# Access Compliance Report

## Public Rights-of-Way

Intersection ID: 47579	Main Street: EVANTON_LOCH_RD	Cross Street: BARRANDS_LN	Location: NE
ADA ID: CC3B5F430D82	Ramp Type: PerpDiag	Initial Pass/Fail: Fail	Overall Compliance: No
		Severity Score: 10

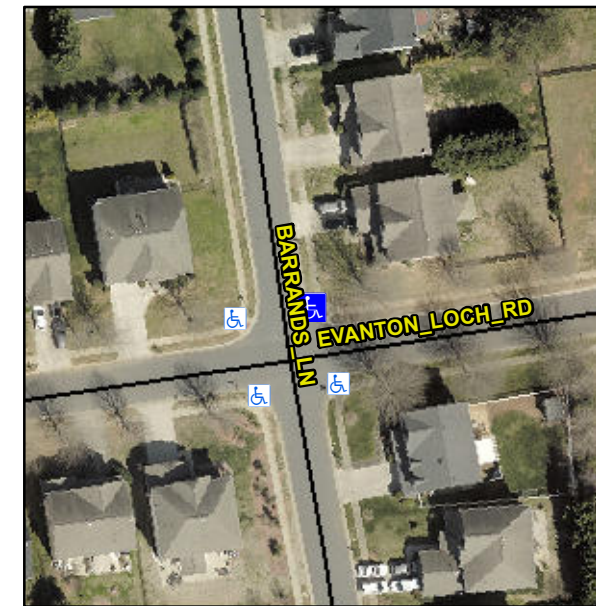
**R304.5.1, R304.5.3**

Compliance	Description	Data	Compliance	Description	Data
N/A	Ramp Length (in)	49.0	Yes	Ramp Slope (%)	5.3
No	Ramp Width (in)	43.5	No	Ramp XSlope (%)	3.0
N/A	Flare Type LT	N/A	N/A	Flare Type RT	N/A
N/A	Flare Slope LT (%)	N/A	N/A	Flare Slope RT (%)	N/A
N/A	Flare Traversable LT?	N/A	N/A	Flare Traversable RT?	N/A
N/A	Landing Length (in)	N/A	N/A	DWS Provided?	N/A
N/A	Landing Width (in)	N/A	N/A	DWS Contrast?	N/A
N/A	Landing Slope (%)	N/A	N/A	DWS Length (in)	N/A
N/A	Landing X Slope (%)	N/A	N/A	DWS Full Width?	N/A
N/A	Landing Curb? (Y/N)	N/A	N/A	DWS Offset (in)	N/A
N/A	Shared Landing?	N/A			
N/A	Gutter Ponding?	N/A	N/A	Gutter Slope (%)	N/A
N/A	Gutter Lip Ht (in)	N/A	N/A	Gutter X Slope (%)	N/A
N/A	Painted X Walk1?	No	N/A	Painted X Walk2?	No
	X Walk 1 Direction	To W		X Walk 2 Direction	To S
N/A	X Walk 1 Width (in)	N/A	N/A	X Walk 2 Width (in)	N/A
	X Walk 1 Slope (%)	4.4		X Walk 2 Slope (%)	1.6
	X Walk 1 X Slope (%)	0.6		X Walk 2 X Slope (%)	2.6

**Remove & Replace Curb Ramp With Two New Directional Ramps or Equivalent.**
